From: Lauren Balisky
Sent: Wednesday, November 17, 2021 8:35 AM
To: 'SYLVIA S KAWABATA'
Cc: permittech; Linda Ritter; Garrett Jensen
Subject: RE: Harbor Grove Subdivision Prelim Plat
Attachments: Notice of Application.pdf

Subject: Harbor Grove Subdivision Prelim Plat

Ref: SD 2021 001/ENG 2021 019/SEPA 2021 010
Harbor Grove Subdivision Preliminary Plat

Critical Area Map near 9110 53rd Ave W
Pertteet Figure 1.2

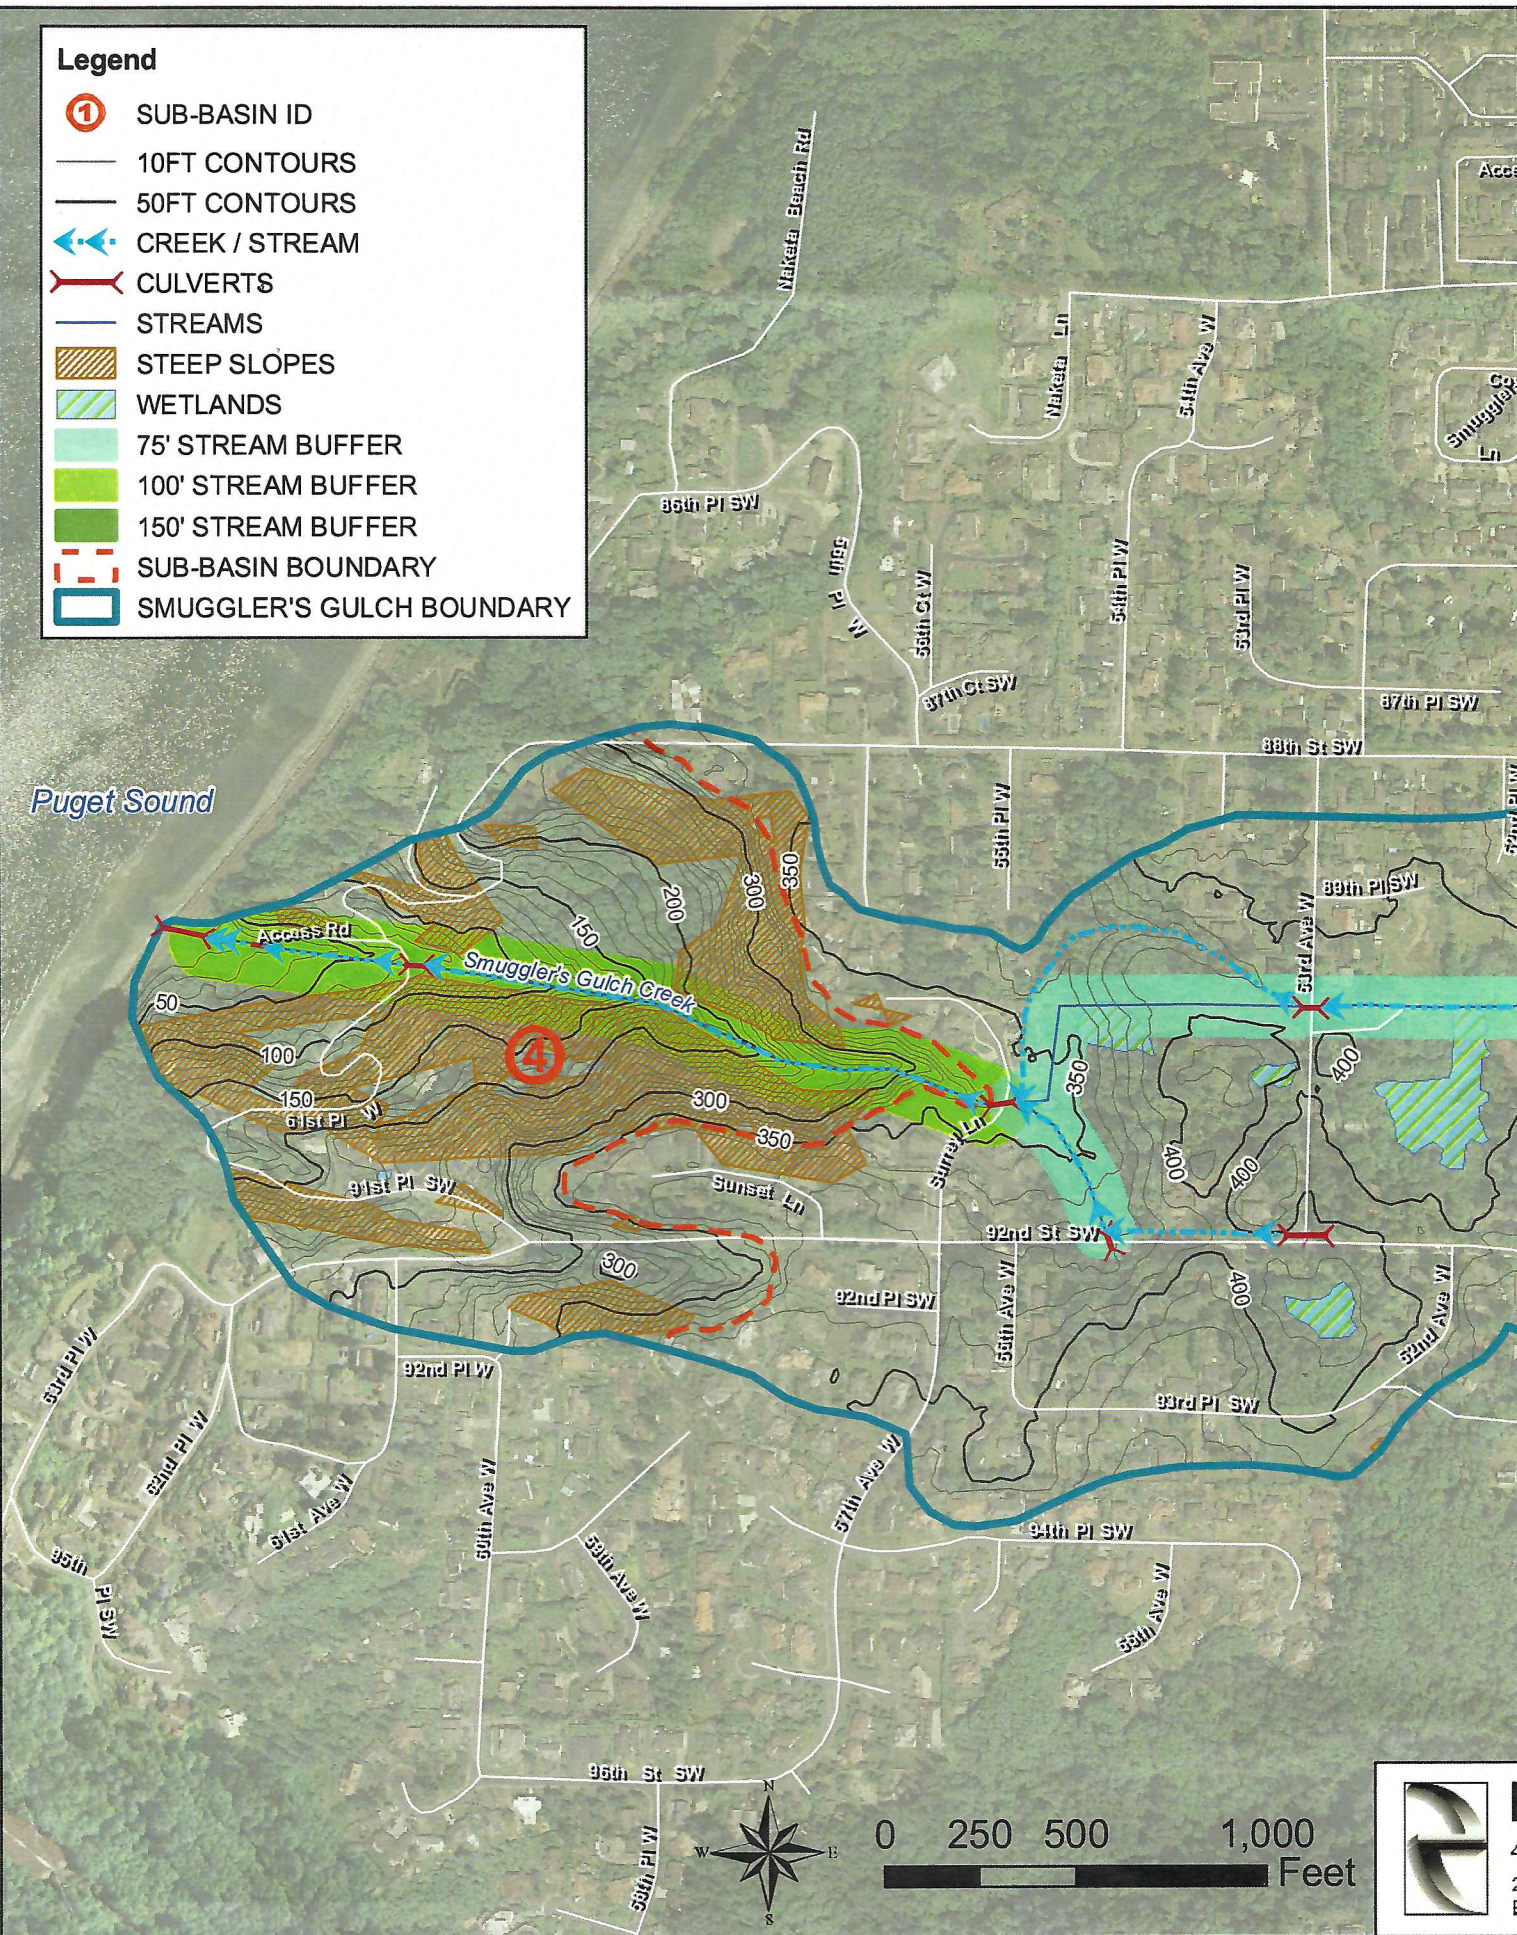
Also, in the City of Mukilteo's Pre-Design Report of the Smuggler's Gulch Stormwater Retrofit Study (dated 8-27-2010, prepared by Perteet) Figure 1.2 identifies a wetland area on the proposed sub-division about 175 feet south of where the creek goes under 53rd Ave W. (A copy of Figure 1.2 is attached.) The applicant needs to address the impacts to this wetland, alternatives to not disturb this wetland and mitigation for its loss if the applicant intends to fill in this wetland area.

Figure 1 - Image showing proposed retaining walls abutting Rugosa Ridge

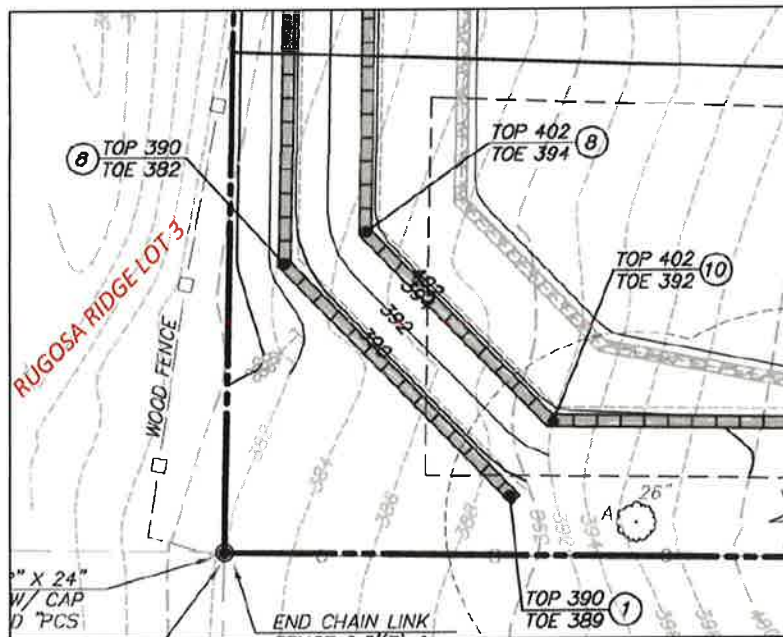
The project includes very large retaining walls along the western boundary of the property. The walls appear to be up to 20 feet in height adjacent to Lot 3 of Rugosa Ridge (see Figure 1 below from grading plan). Not only would the walls be visible from the abutting lots in Rugosa, they would be visible from many vantage points in our subdivision, including from the public street. The walls would be massive and unsightly. For that reason, the HOA strongly opposes the use of large retaining walls supporting large amounts of fill.

Figure 1 – French drain and connection to stormwater collection system

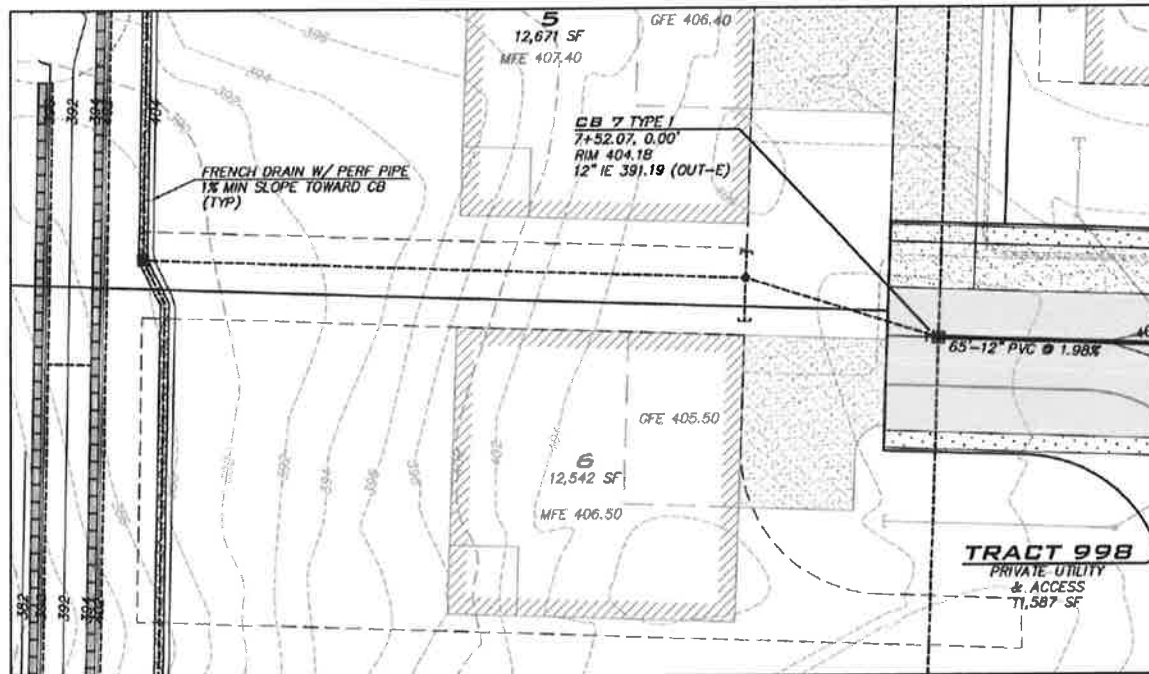
French drain. The proposed french drain to be installed across Lots 4-7 will be buried under approximately 10-12 feet of fill dirt (see Sheet 7 of the preliminary plans and Figure 1 below). How will this drain be maintained? What will happen if it fails? Will it be possible to bring equipment into the back yards of future homeowners and dig a 12 foot deep trench? Future property owners will have no incentive to maintain the drain systems because failure would mostly impact other properties outside of the development. My guess is this drain will never be maintained or repaired, and if it fails, it will cause major drainage issues for my property and my neighbors. Such a failure would be nearly impossible to detect and locate, much less to fix. There is also a possibility that future homeowners will cover the drain area with patios and other hard surfacing, making it less effective.

The french drain will flow back to the east in a pipe connected to the detention system. The slope gradient of this pipe is specified at a minimum of 1%, which is barely enough for the water to flow in its intended direction (see Sheet 7). In order to flow back to the east, this drain will need to be installed at a minimum elevation of 393' because the catch basin elevation will be set at 391' (Sheet 7 and Figure 1, below). The french drain collection pipe will be *above* the existing grade level of approximately 386' to 392'. This is significant because the drain will be at too high of an elevation to capture all of the site's subsurface drainage. It would be located above the layer of glacial till that underlies the site. Because of the site's sloping topography, water is likely pass *under* the pipe, contact the glacial till layer, and migrate to the west. And what would happen if the site were to experience post-development settlement, changing the gradient of the pipe? Could it potentially stop flowing? These are valid questions since the proposal is to place a massive amount of fill material on the site.

The effectiveness of this project's subsurface drainage system will be reduced as a result of the applicant's design objective of sending collected water back to the east. System improvements, including the french drain, would be installed at too high of an elevation. The City should require the applicant to prepare an alternative design that places the subsurface drainage collection system at a lower elevation to more effectively capture subsurface water. The design should be prepared in close coordination with a groundwater study and a revised soils study. Long-term access and maintenance provisions should be included for this or any system.

Figure 1 – Detention Vault “Bypass Basin” Area (highlighted in yellow)

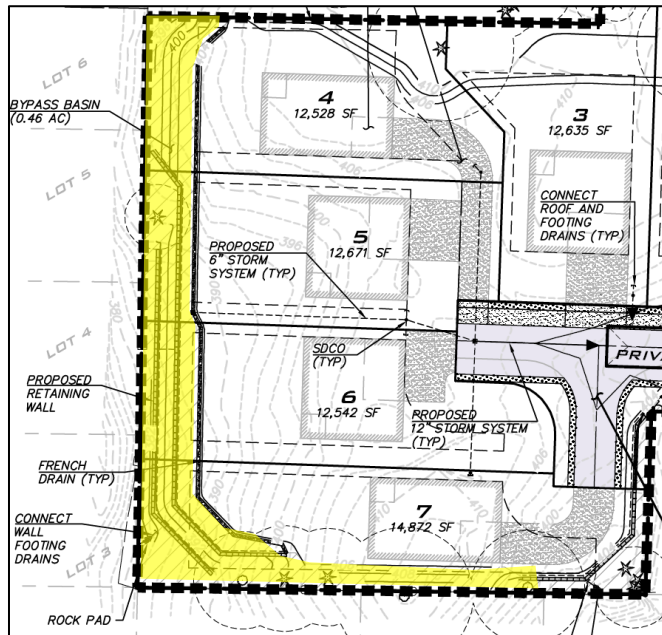
- C. Bypass Basin. The drainage study identifies a "bypass basin" consisting of 0.46 acres of land that will not drain to the detention vault (see pages 4.3, 4.4 and Developed Conditions Exhibit and Figure 1 below). This area is located along the west and south property lines of the project site and directly abuts several properties in Rugosa Ridge. The drainage study contains no analysis of potential impacts on adjacent properties and must be amended to address this issue since nearly 20% of the developed project site will bypass the storm system and flow to adjacent properties. The amount of runoff generated post-development from the bypass basin would exceed runoff from existing

conditions as a result of removal of all existing vegetation. This information also supports a requirement for a groundwater study.

Figure 2 – Areas of 35-40% slopes

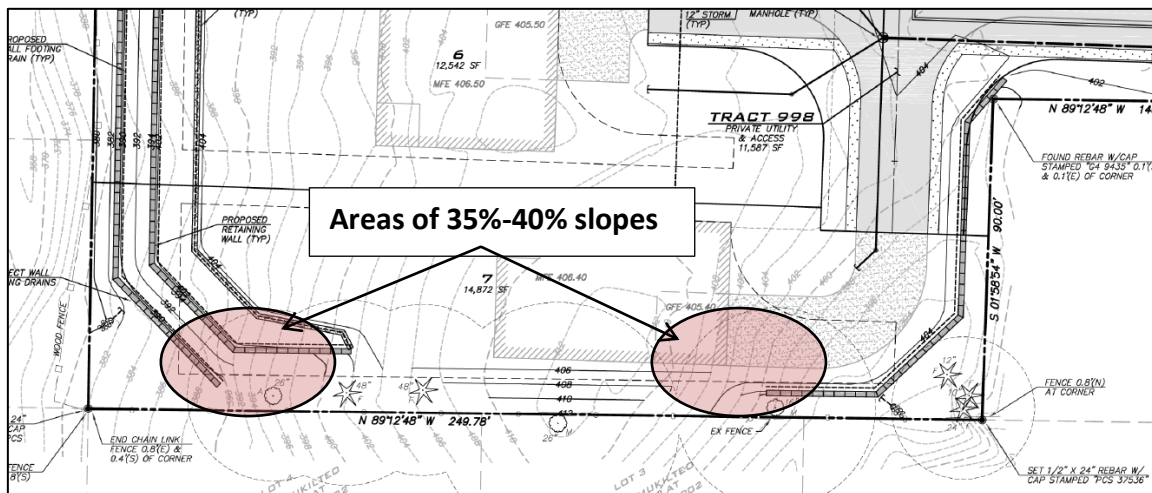
2. Groundwater/Hydrology Study. The need for a groundwater/hydrology study is further supported by the following:
 - A. 15.16.050.C.2.b.i.(b), which requires a slope and hydrology report when clearing/grading on slopes greater than 35%. The south and southwest portions of the site contain slopes greater than 35% (see Figure 2 below from Grading Plan, Sheet 5). I calculated slopes up to 40%.
